Access Compliance Report

Public Rights-of-Way

(Curb Ramps)

Intersection ID: 20050	Main Street: SARDIS_RD	Cross Street: CHEVRON_DR	Location: SE
ADA ID: 06151F2B2C5C	Ramp Type: PerpDiag	Initial Pass/Fail: Fail	Overall Compliance: No
Codes/Mitigation Info/Possible Solution		Field Measurements/Component Compliance	
Severity Score: 25

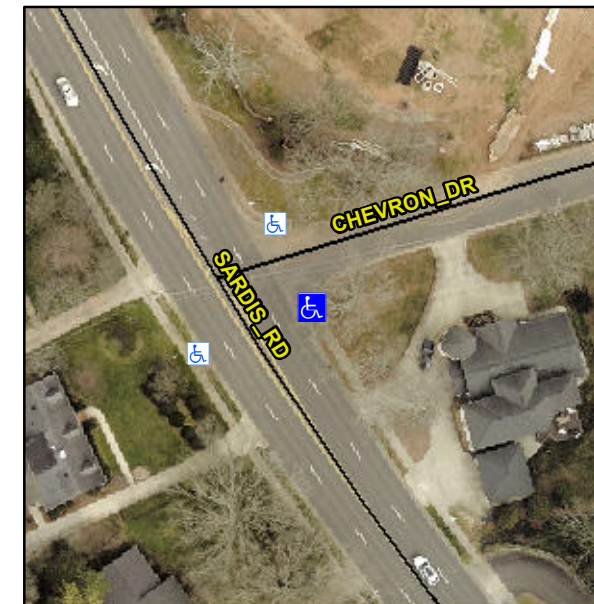
Not Found, R304.2.2, R304.5.3

Compliance	Description	Data	Compliance	Description	Data
N/A	Ramp Length (in)	57.0	No	Ramp Slope (%)	8.5
Yes	Ramp Width (in)	61.0	No	Ramp XSlope (%)	5.3
N/A	Flare Type LT	N/A	N/A	Flare Type RT	N/A
N/A	Flare Slope LT (%)	N/A	N/A	Flare Slope RT (%)	N/A
N/A	Flare Traversable LT?	N/A	N/A	Flare Traversable RT?	N/A
N/A	Landing Length (in)	N/A	N/A	DWS Provided?	N/A
N/A	Landing Width (in)	N/A	N/A	DWS Contrast?	N/A
N/A	Landing Slope (%)	N/A	N/A	DWS Length (in)	N/A
N/A	Landing X Slope (%)	N/A	N/A	DWS Full Width?	N/A
N/A	Landing Curb? (Y/N)	N/A	N/A	DWS Offset (in)	N/A
N/A	Shared Landing?	N/A			
N/A	Gutter Ponding?	N/A	N/A	Gutter Slope (%)	N/A
N/A	Gutter Lip Ht (in)	N/A	N/A	Gutter X Slope (%)	N/A
N/A	Painted X Walk1?	No	N/A	Painted X Walk2?	No
	X Walk 1 Direction	To NW		X Walk 2 Direction	To SW
N/A	X Walk 1 Width (in)	N/A	N/A	X Walk 2 Width (in)	N/A
	X Walk 1 Slope (%)	1.6		X Walk 2 Slope (%)	3.1
	X Walk 1 X Slope (%)	3.1		X Walk 2 X Slope (%)	2.3

Remove & Replace Curb Ramp With Two New Directional Ramps or Equivalent.
